A303 Amesbury to Berwick Down

**8.46 – Response to English Heritage objection to PRow to
Visitor Centre**

Response to English Heritage objection to PRow to Visitor Centre

Regulation Number:	Regulation 5(2)(q)
Planning Inspectorate Scheme Reference	TR010025
Application Document Reference	8.46
Author:	A303 Amesbury to Berwick Down Project Team, Highways England

A360 TO STONEHENGE
VISITOR CENTRE
MU FACILITIES ALONG A344
OTPION D

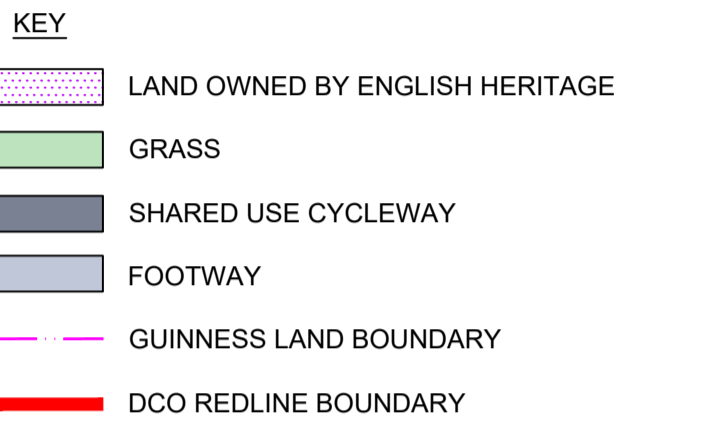
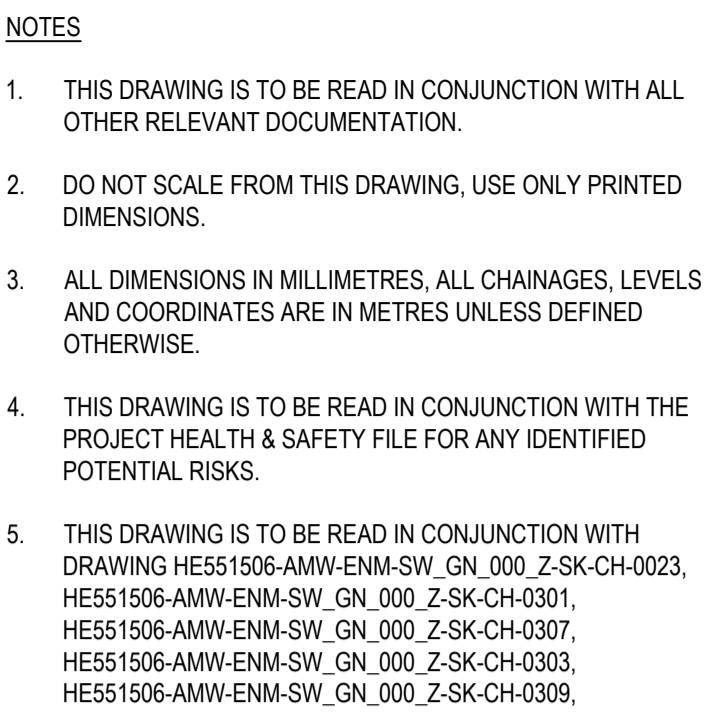
- 6.4.1 Option D adopts the same alignment as Option A. However, in option D the shared-use path would terminate opposite the coach park access road and immediately to the east of the gate, preventing public vehicle access onto the C506 (former A344). The proposed footway would extend in an easterly direction to meet the existing footway between the Visitor Centre and the coach park. Additional land (an area of 652m²) outside the Order Limits would be required. Option D is shown on drawing HE551506-AMW-ENM-SW_GN_000_Z-SK-CH-0311 in Appendix 3 to this report.
- 6.4.2 Option D would encourage pedestrians heading east towards Stonehenge to do so via the Visitor Centre rather than via the shuttle bus stop or turnaround. This would minimise the potential conflict between PRoW users and the operation of the Visitor centre. As such option D is considered to be

the preferred option and has been incorporated in each of the options included in the Applicant's Proposed Change Application (i.e. NMC-06, Options A and B, in AS-067).

Drawing Title
NMU A360 TO STONEHENGE
VISITOR CENTRE
PEDESTRIAN CROSSING
OPTIONS A TO F

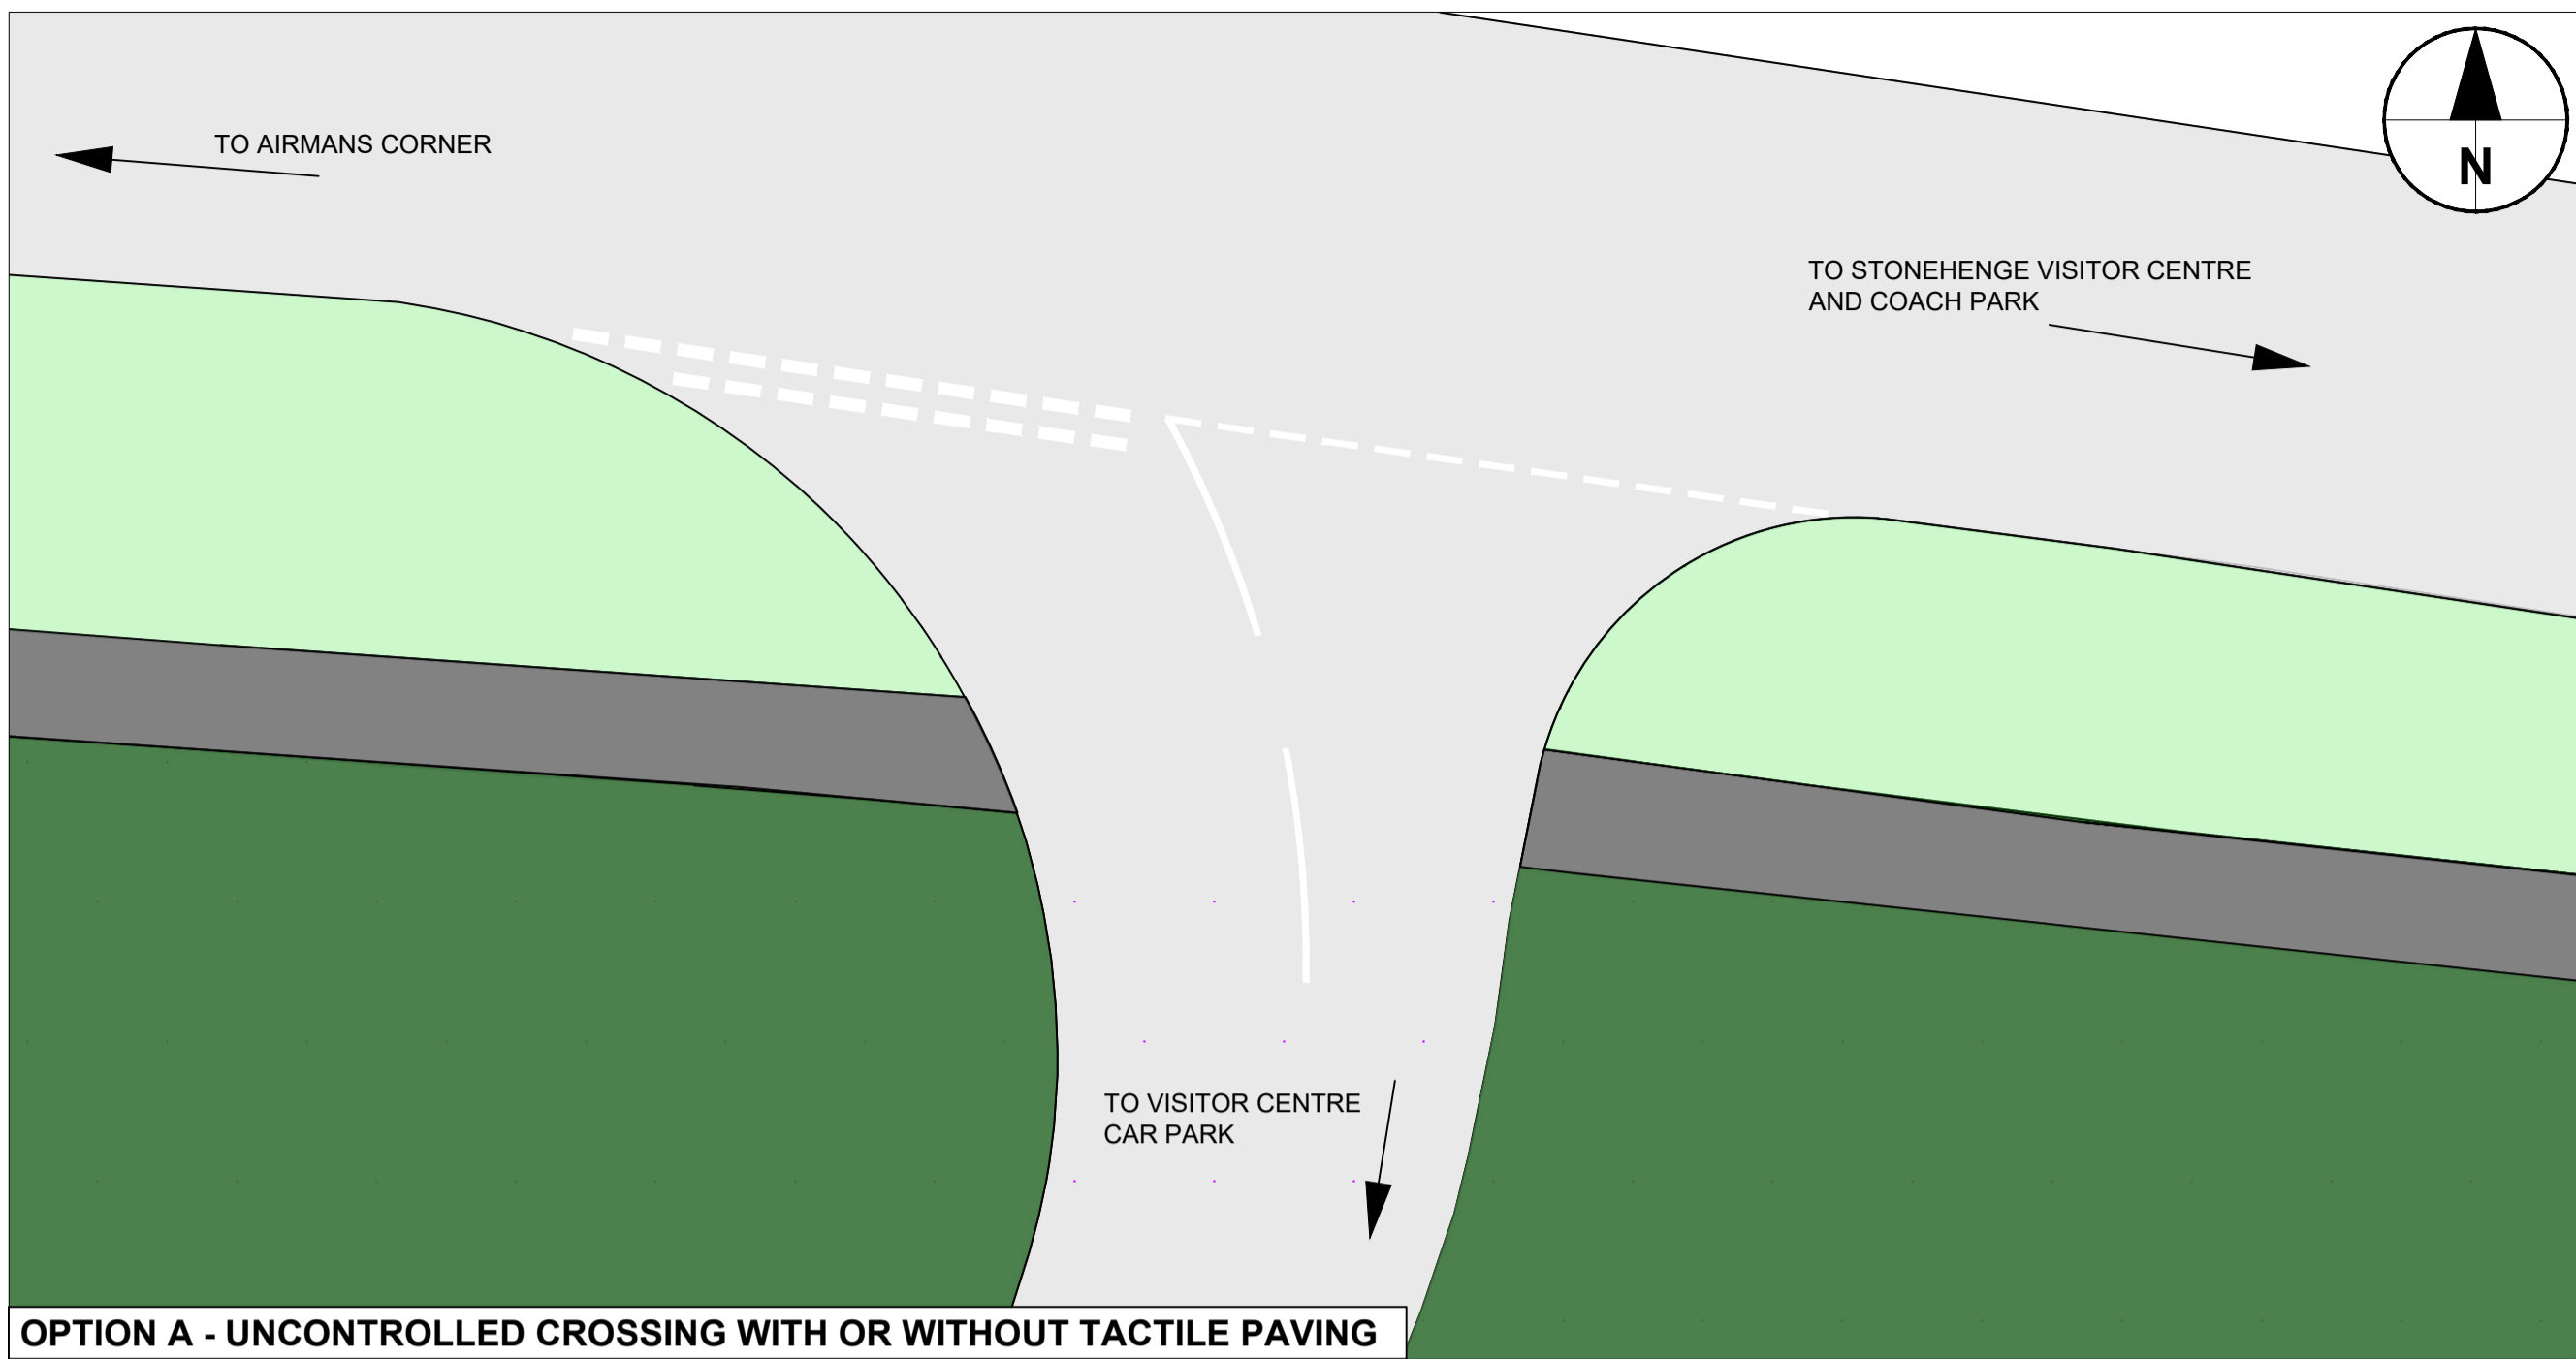
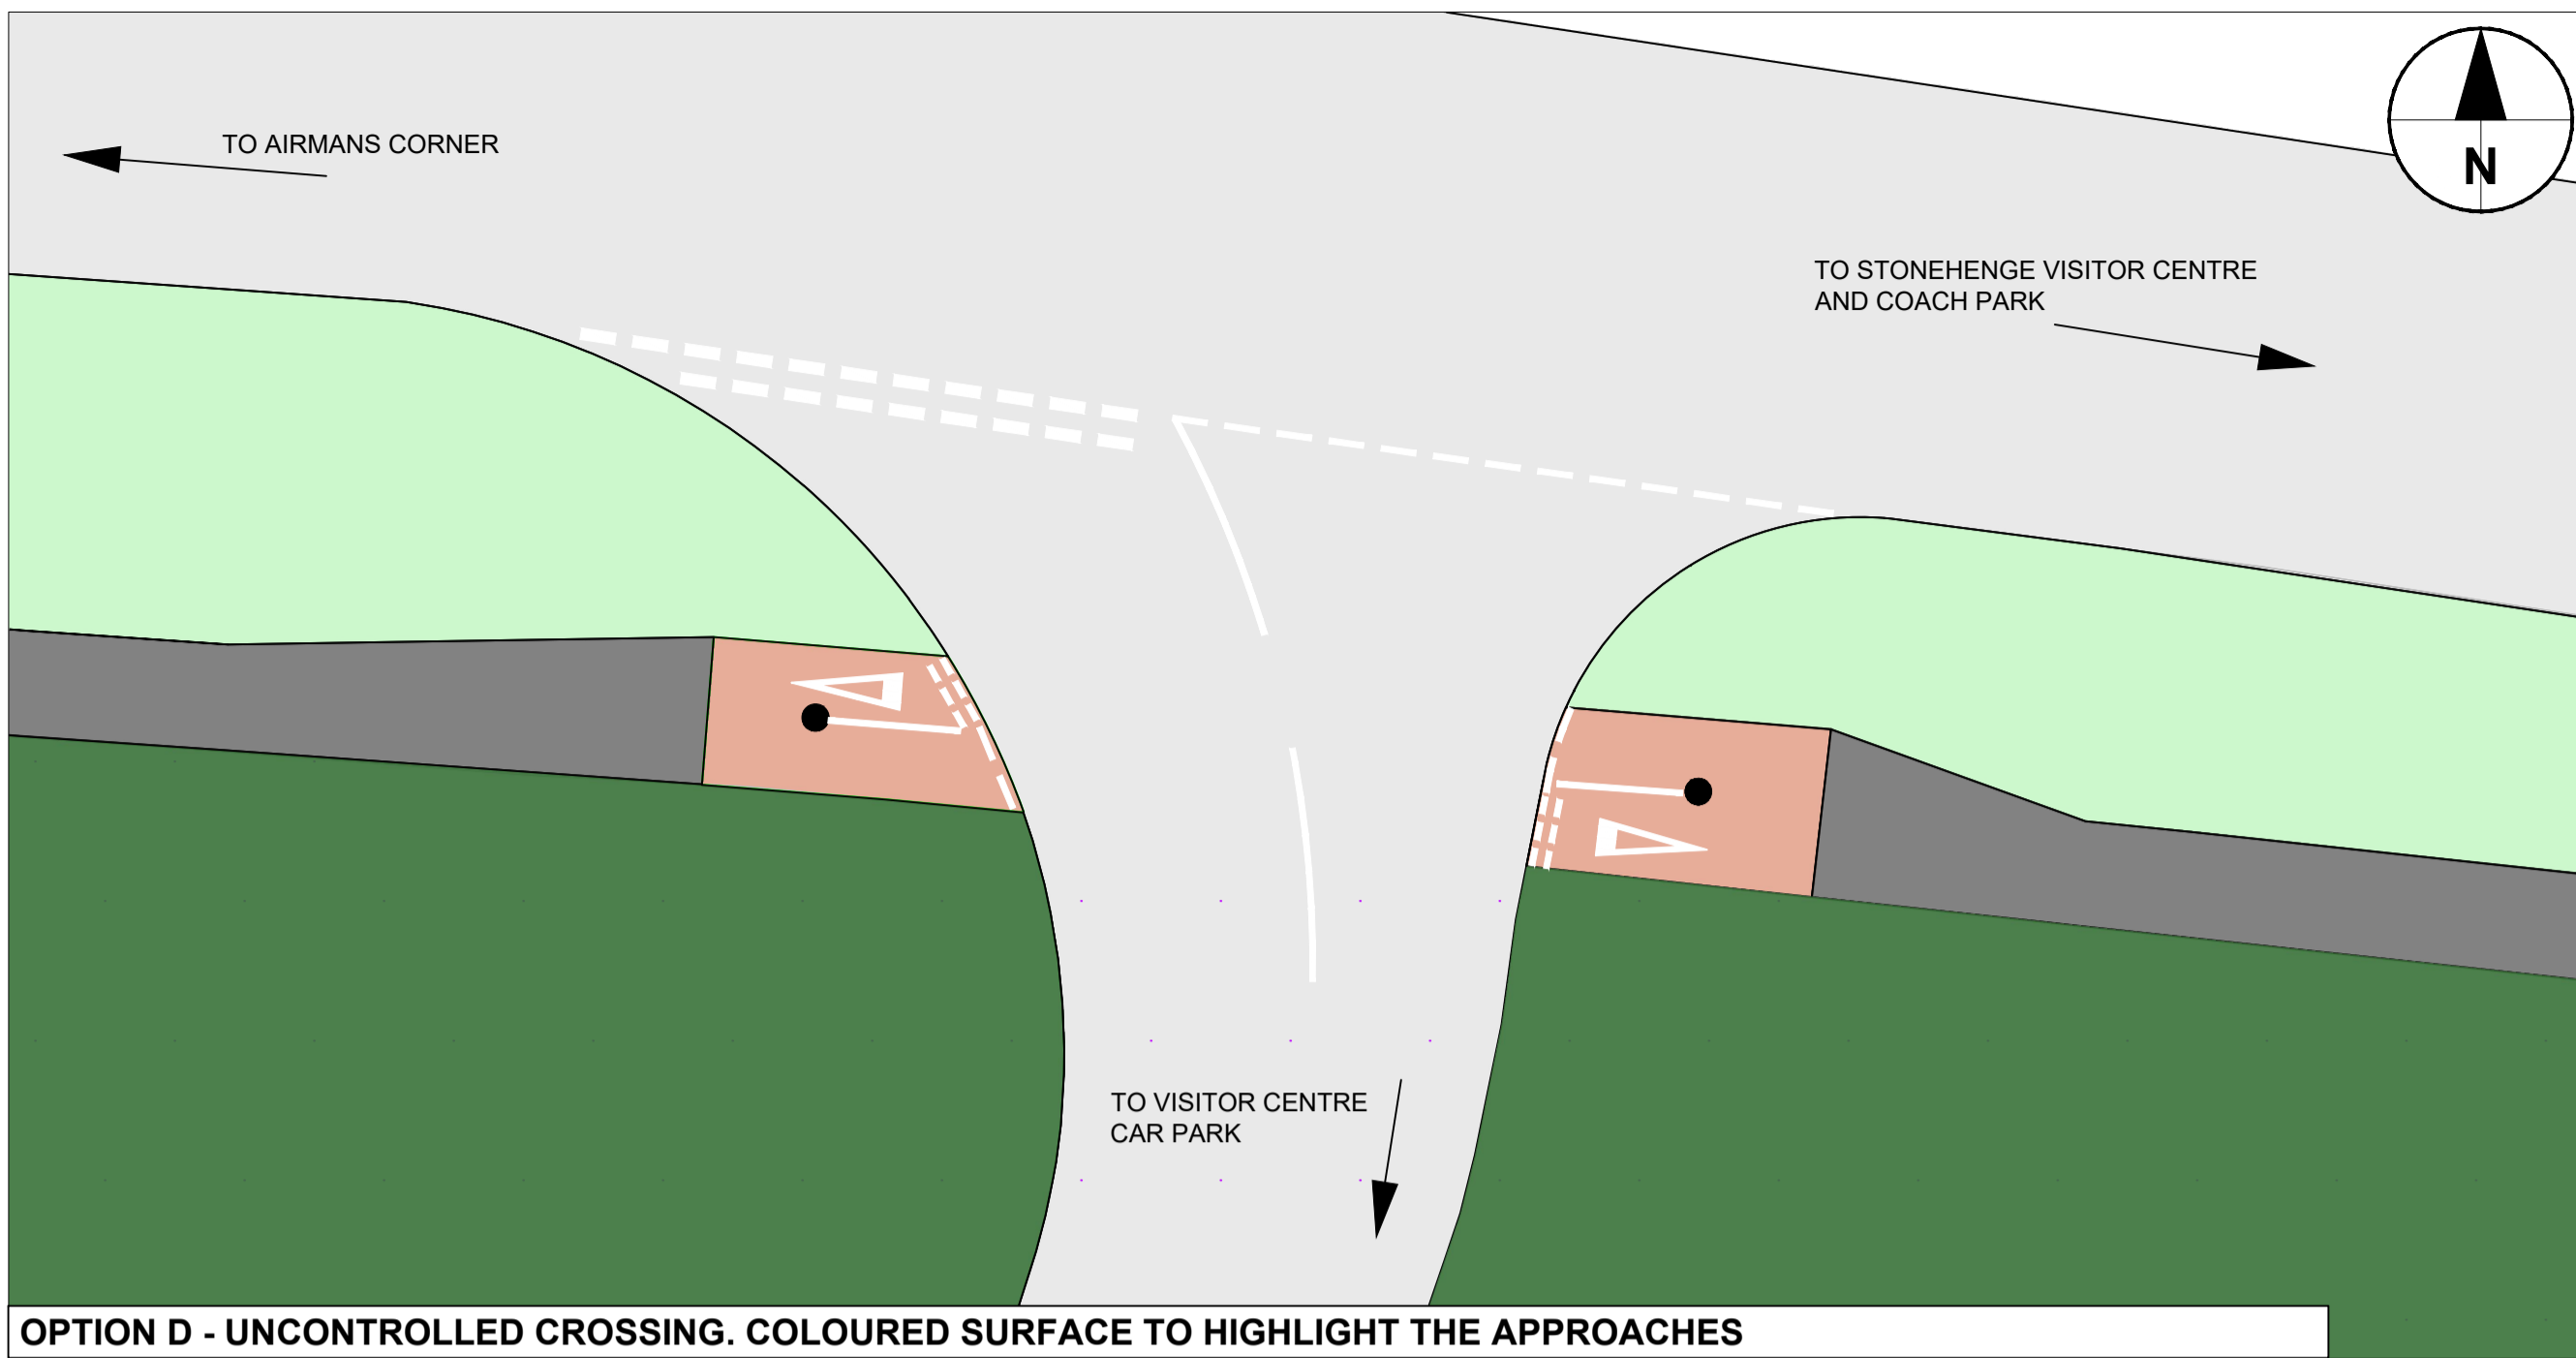
- 7.3.3 At the car park access road crossing, a number of options have been developed. Each one gives priority to the vehicles entering the car park. These options are illustrated in drawing No HE551506-AMW-ENM-SW_GN_000_Z-SK-CH-0017. See Appendix 3 to this report.
